**The W Nursing School
Neshoba General
Philadelphia, MS**

Addendum No. 2

June 10, 2026

This addendum forms a part of the contract documents and modifies the original plans and specifications dated June 4, 2026.

8 LAB 314 WEST A
3/8" = 1'-0"

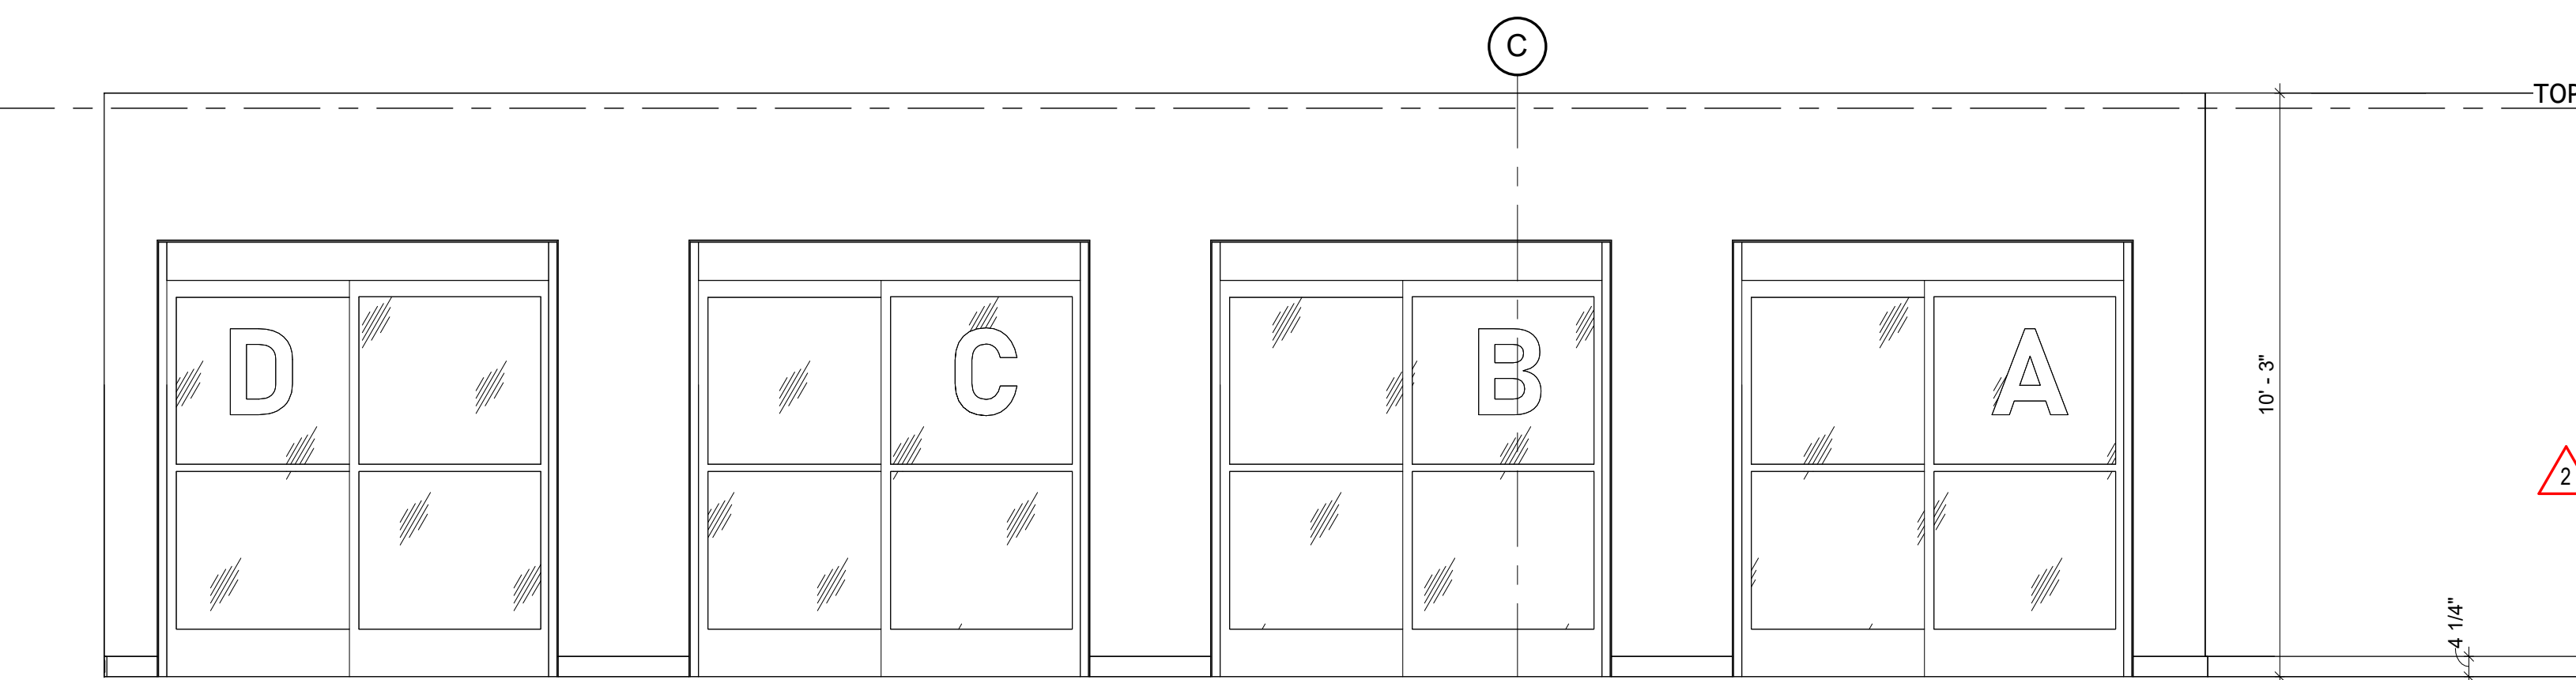
Item 2.10: Sheet A-502

Note: See clouded millwork detail references.

sheet no.
A-701
of

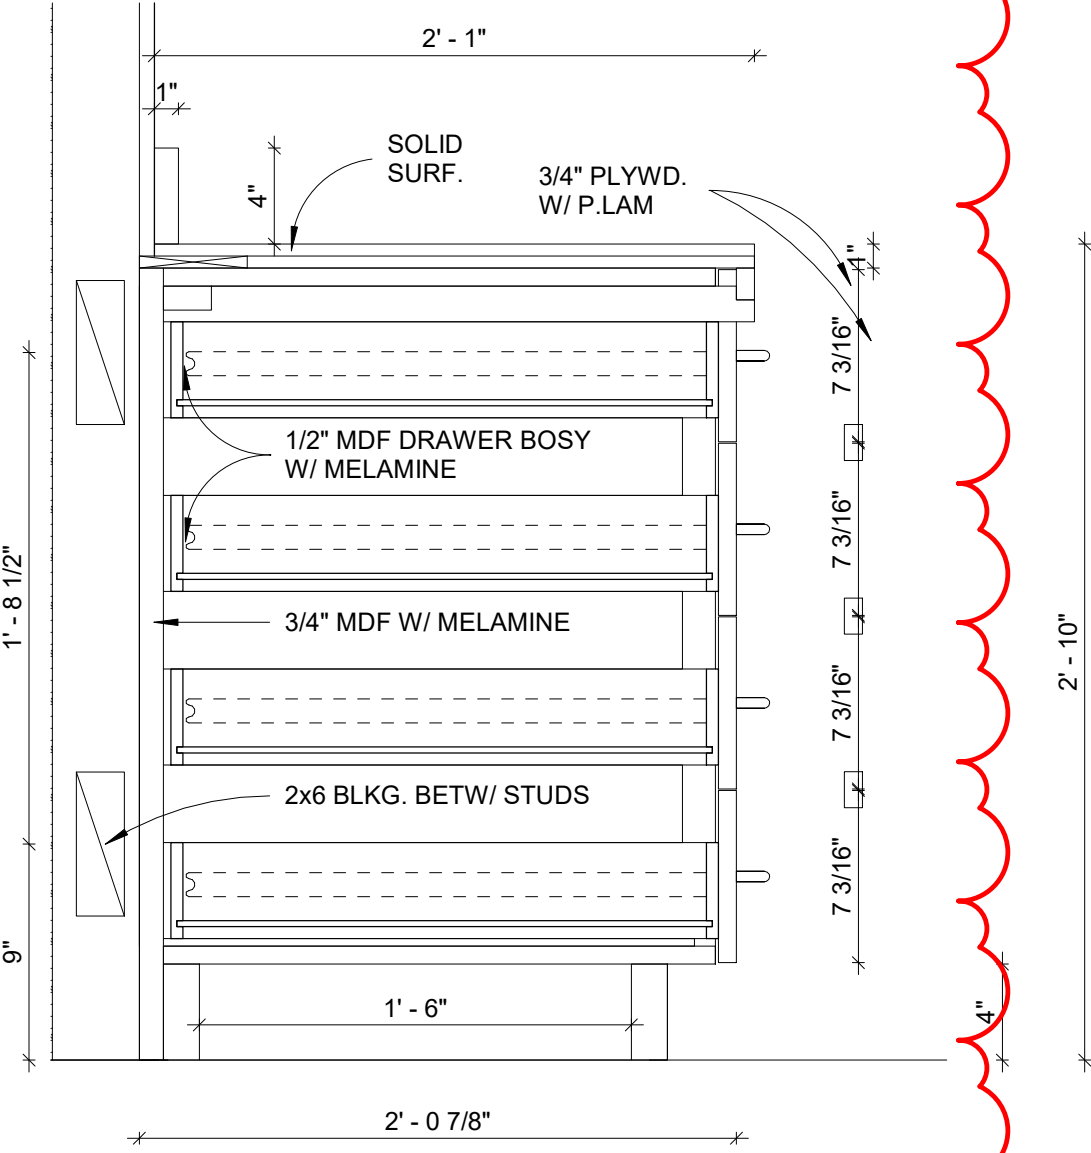
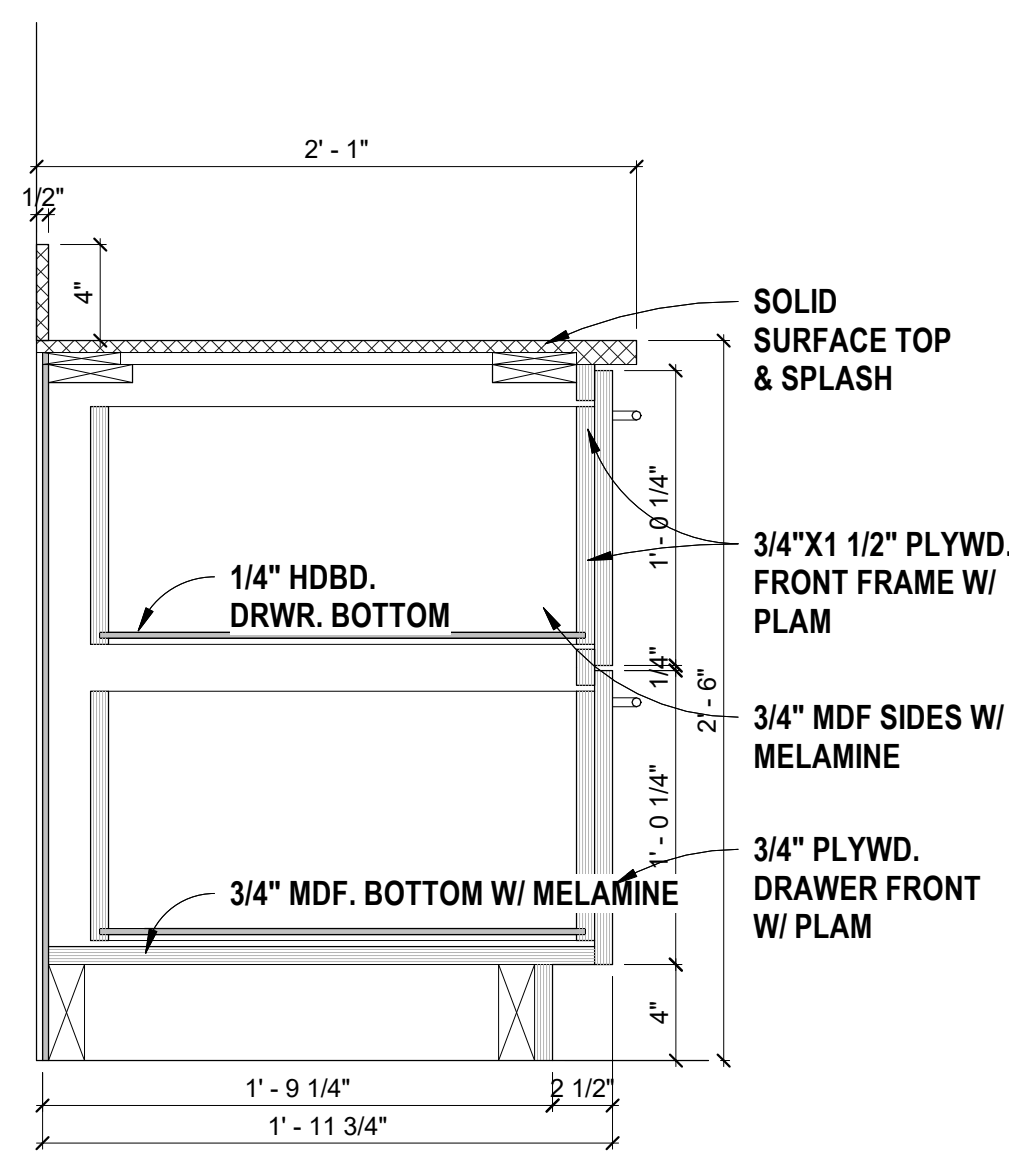
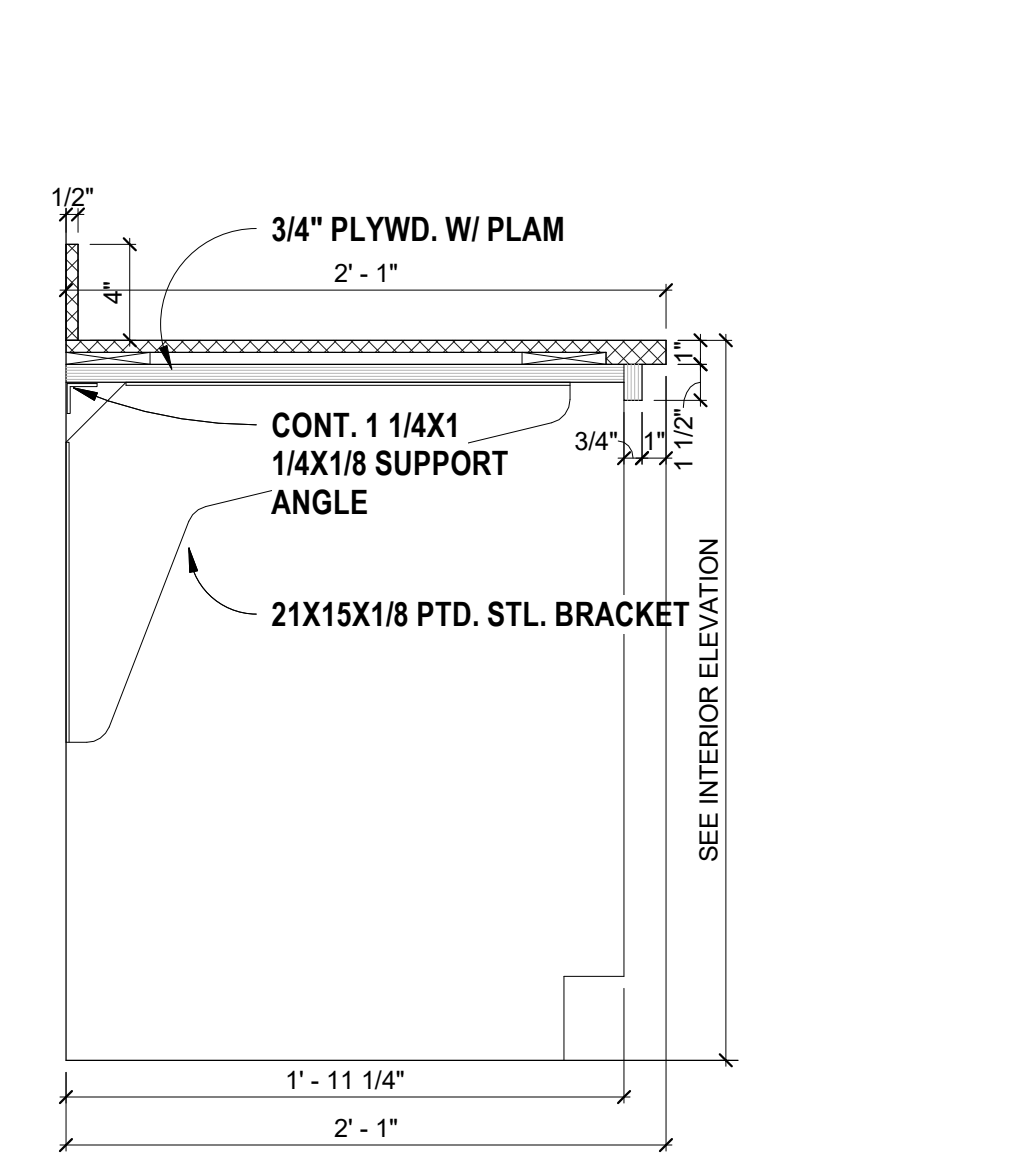
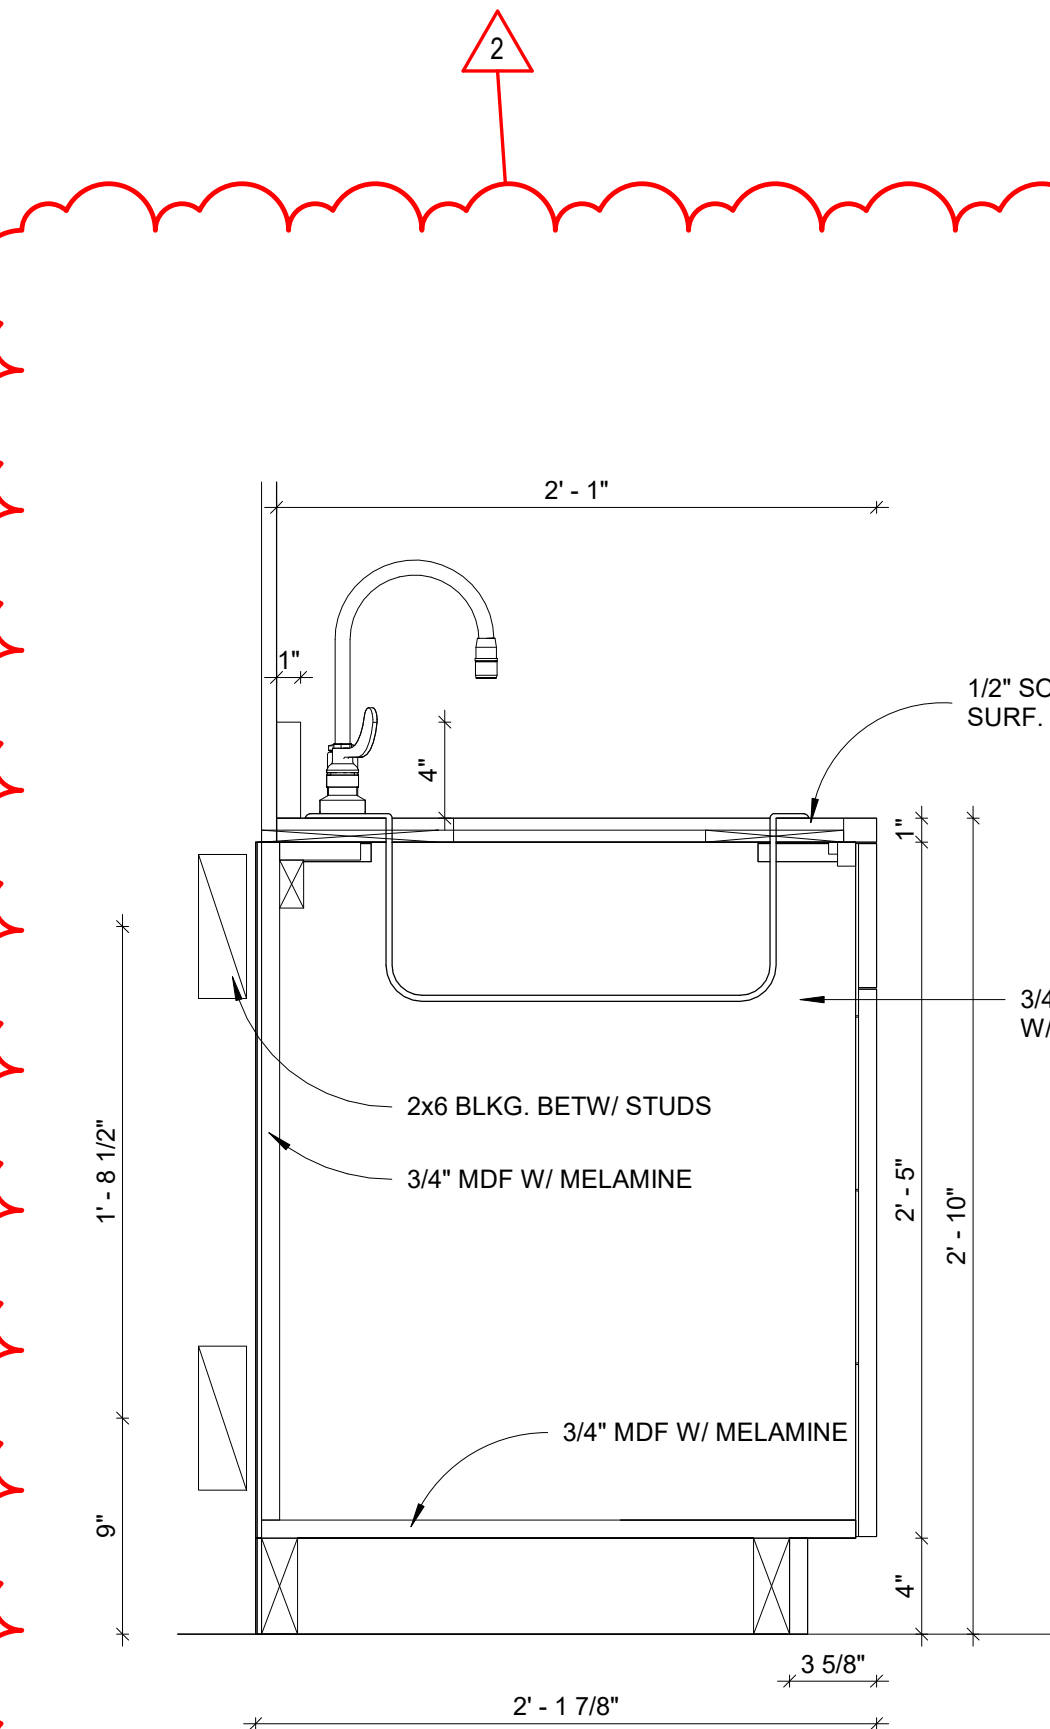
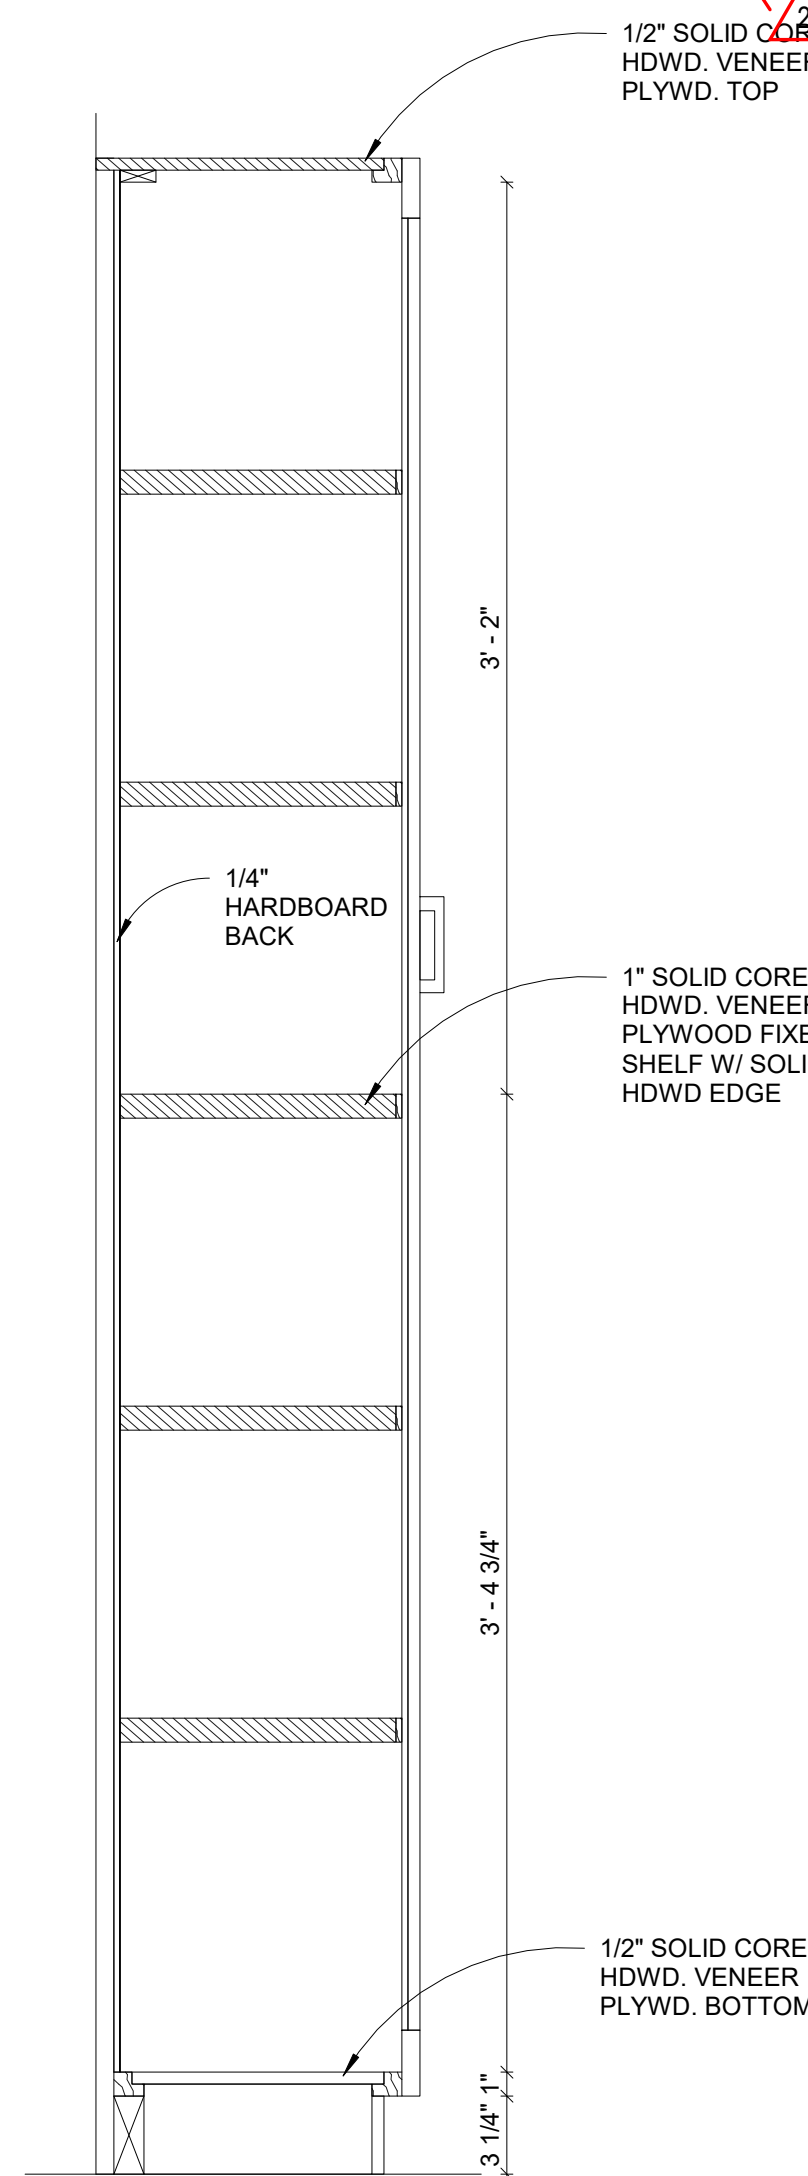
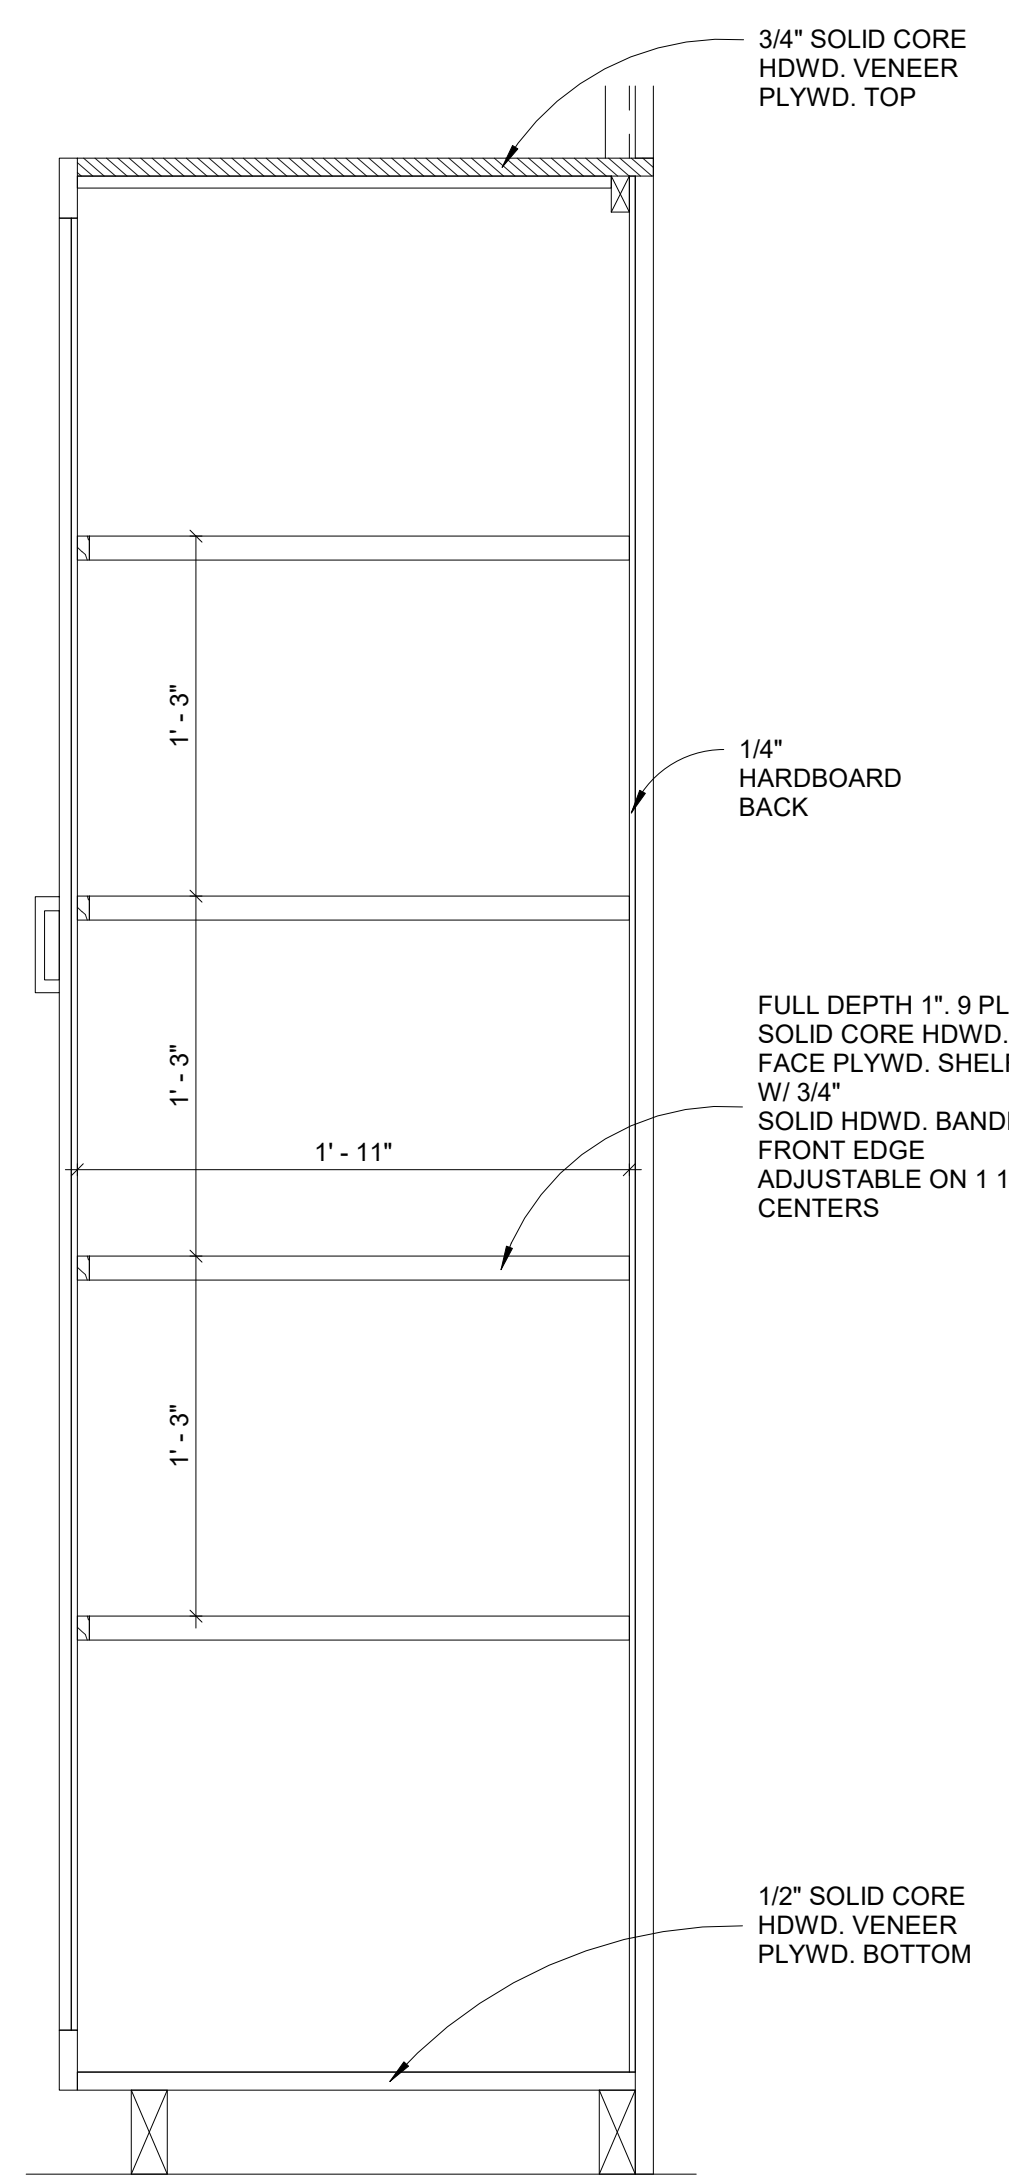
Item 2.15: Sheet A-701

Note: See clouded millwork detail 5/A701.
